SERVICE NOTIFICATION

Models Affected: 2008 SunTracker "HP" (High Performance) Pontoon Boats equipped with Trailstar trailers.

Condition: In some cases the upright w/roller design has caused significant damage to the high performance strakes.

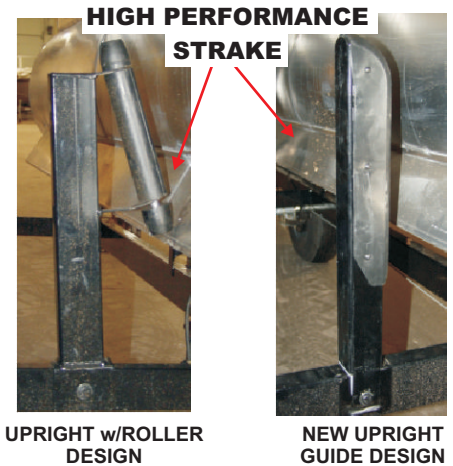
Tracker Marine Group has discovered a concern regarding the 2008 SunTracker "HP" (High Performance) Pontoon boats equipped with Trailstar trailers. In some cases the upright w/roller design has caused significant damage to the high performance strakes.

Newly designed upright guide kits are being **automatically** sent to dealerships to which the trailers were originally shipped. The kits contain the fully assembled uprights and a hardware pack. Using the provided instructions, change out the upright guides to resolve the concern.
